Product Change Notification - SYST-14YTT0745

ERRATA - dsPIC33EVXXXGM00X/10X Family Silicon Errata and Data Sheet Clarification

Description of Change: 1) Addition of silicon die revision AD. 2) Added data sheet clarification 2 (Electrical Characteristics)

dsPIC33EVXXXGM00X/10X Family Silicon Errata and Data Sheet Clarification

FIGURE 1:

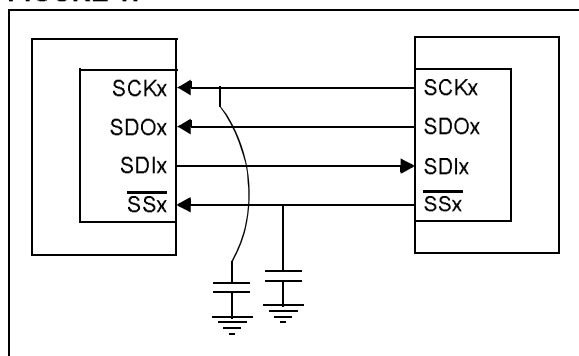
When the SPIx module is configured in SPIx Slave mode (MSTEN bit (SPIxCON1[5]) = 0), the frame slave (FRMEN bit (SPIxCON2[15]) = 1) and the SPIFSD bit (SPIxCON2[14]) = 1), in Standard Buffer mode with the Clock Polarity Select bit, CKP = 0, the data is not transmitted in both 8-bit and 16-bit mode, but the data is being received correctly.

Adding a capacitance on the signal, as shown in Figure 1, will help the data to be received properly.

FIGURE 2: TIMING DIAGRAMS FOR CENTER-ALIGNED AND EDGE-ALIGNED MODES

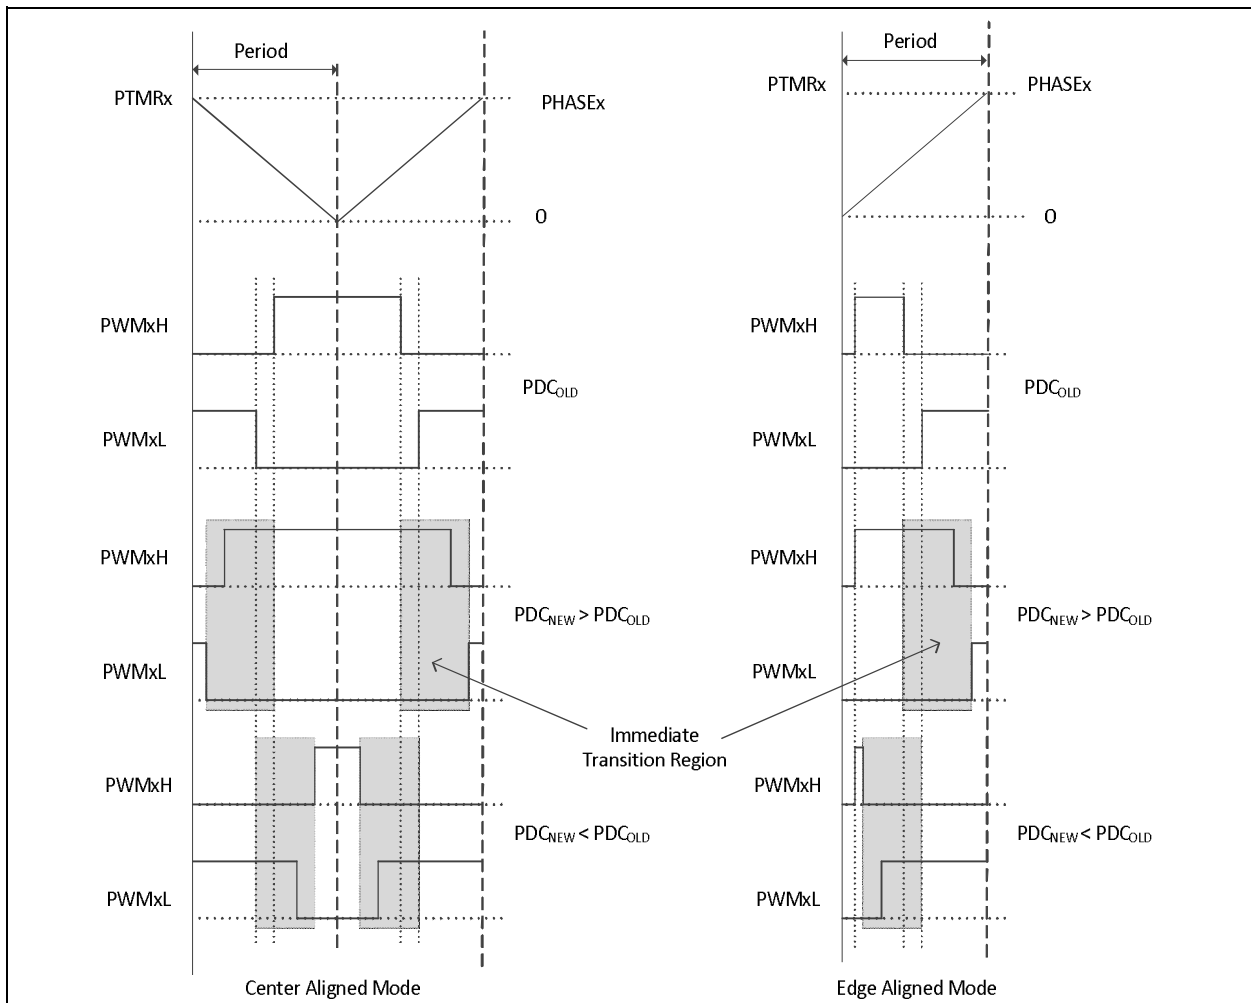
The PWM generator may not assert dead time on the edges of transitions. This has been observed when all of the following conditions are present:

In [Figure 2](#), if the duty cycle write occurred in the shaded box, then PWMxH and PWMxL will make an immediate transition without dead time.

However, in most applications, the duty cycle update timing can be controlled using the TRIGx trigger or Special Event Trigger, such that the above mentioned conditions are avoided altogether.

FIGURE 3: ILLUSTRATION OF 1 TOSC GLITCH WHEN PWM OVERRIDE IS TURNED OFF

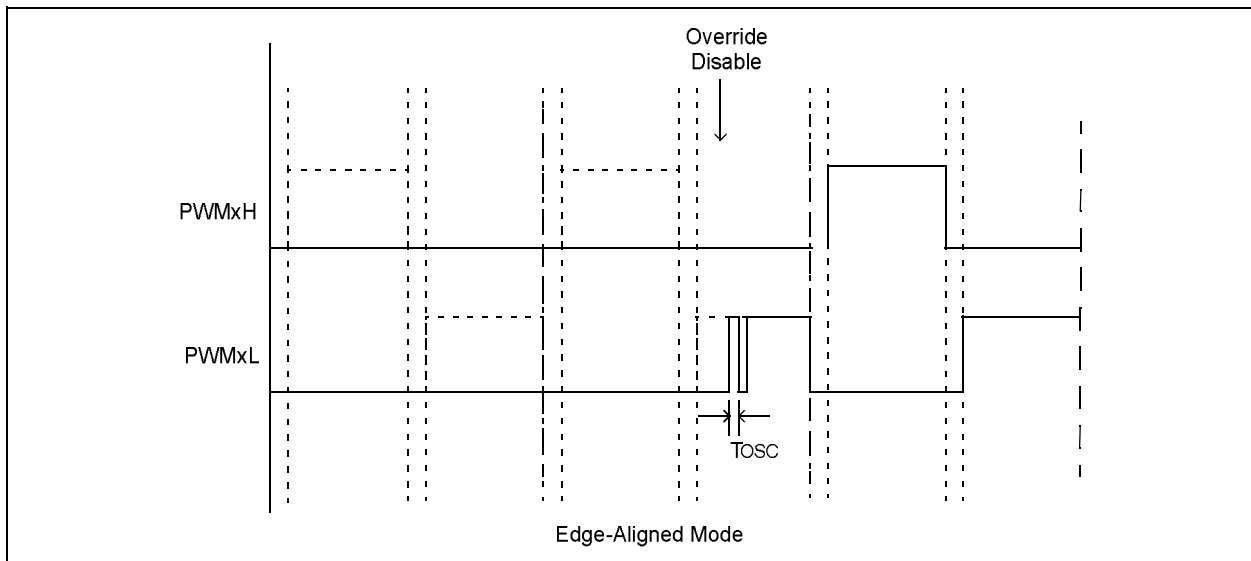
In Complementary mode after the PWM module is enabled ($PTEN = 1$), if the PWM override is turned off, a one TOSC glitch will be present on the rising edge of either the PWMxH or PWMxL pins, whichever occurs first, as shown in Figure 3.

The glitch will be present on PWMxH/PWMxL every time the override state is changed from override enabled to override disabled. The width of this glitch is equal to one TOSC when $PCLKDIV[2:0]$ ($PTCON2[2:0]$) = 000. Increasing the PWMx input clock prescaler setting will increase the width of the glitch accordingly.

FIGURE 4:

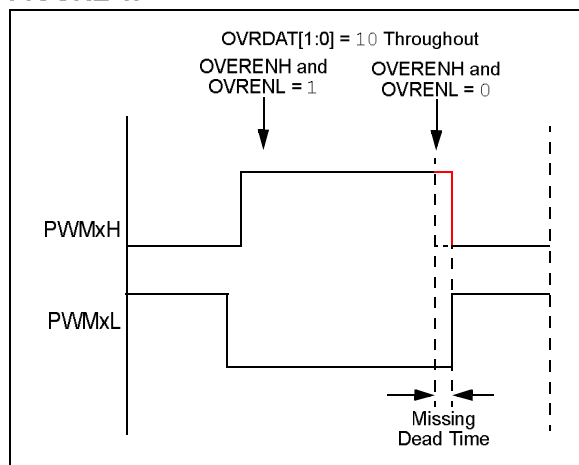
In Complementary Output mode, the expected dead time between transitions of the PWMxH and PWMxL outputs may not be asserted when the following occurs:

- Output override synchronization is configured to occur on the CPU clock boundary (IOCONx[0] = 0);
- Both PWMxH and PWMxL overrides are enabled prior to the event (OVRENH and OVRENL are both '1'), and
- Both overrides are disabled (OVRENH and OVRENL are both '0') at the instant the dead time should be asserted (Figure 4). This has been observed in both Center-Aligned and Edge-Aligned modes.

FIGURE 5:

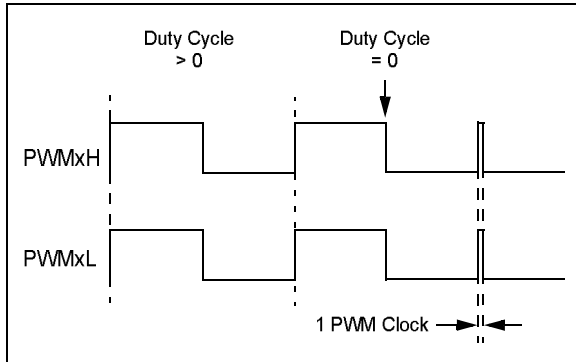
In the Redundant Output mode (IOCONx[11:10] = 10) and Push-Pull Output mode (IOCONx[11:10] = 01) with Immediate Update disabled (PWMCONx[0] = 0), when the Duty Cycle register is updated from a non-zero value to zero, a glitch pulse of a width equal to one PWM clock will appear at the next PWM period boundary, as shown in Figure 5, for the Redundant Output mode. Here, the Duty Cycle register refers to the PDCx register if PWMCONx[8] = 0 or the MDC register if PWMCONx[8] = 1.

If the application requires a zero duty cycle output, there are two possible work around methods:

1. Use the PWM override feature to override the PWM output to a low state instead of writing to the Duty Cycle register. In order to switch back to a non-zero duty cycle output, turn off the PWM override. The override-on and override-off events must be timed close to the PWM period boundary if the IOCONx register has been configured with IOCON[0] = 0 (i.e., output overrides via the OVDDAT[1:0] bits occur on the next CPU clock boundary).

2. Enable the Immediate Update (PWMCONx[0] = 1) while configuring the PWM module, i.e., before enabling the PWM module (PTCON[15] = 1). With Immediate Update enabled, writes to the Duty Cycle register can have an immediate effect on the PWM output. Hence, duty cycle write operations must be timed close to the PWM period boundary in order to avoid distortions in the PWM output.

FIGURE 7: SIMPLIFIED BEHAVIOR

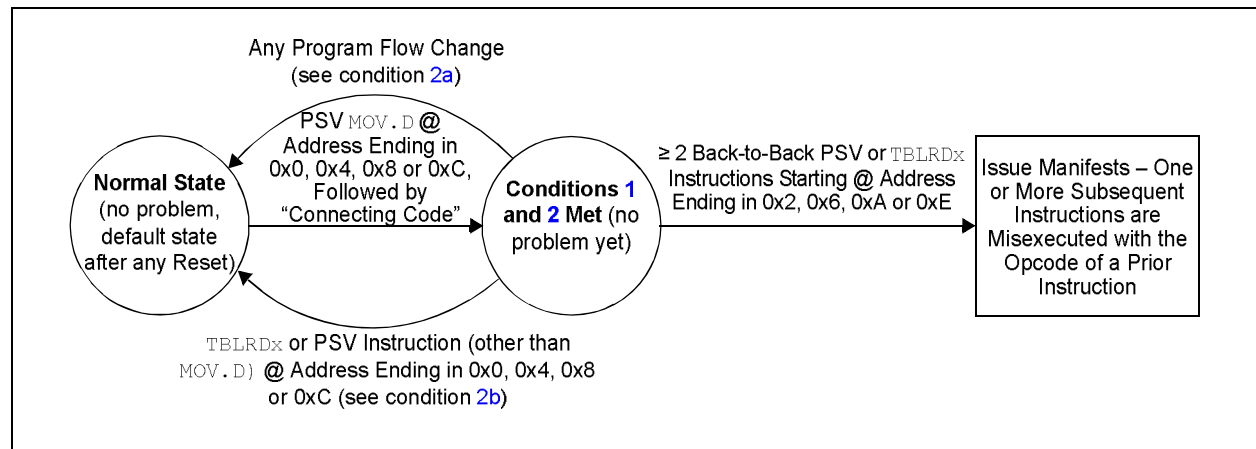
3.	≥ 2 back-to-back PSV or TBLRDx instructions are executed (following the code of condition 2), where the first of the back-to-back instructions is located at an address ending in 0x2, 0x6, 0xA or 0xE.

[Figure 7](#) provides an example of the effective behavior.

1. All instances of PSV MOV.D can be replaced with two PSV MOV instructions instead. Non-PSV MOV.D instructions acting on RAM/SFRs do not need to be modified; or
2. If not already present, a program flow change instruction (such as BRA \$+2) can be inserted above back-to-back data Flash read sequences; or
3. Back-to-back data Flash read instruction sequences can be broken up by inserting a non-Flash read instruction (such as a NOP), in between the Flash read instructions; or
4. The alignment of the code can be shifted to avoid the required opcode location addresses.
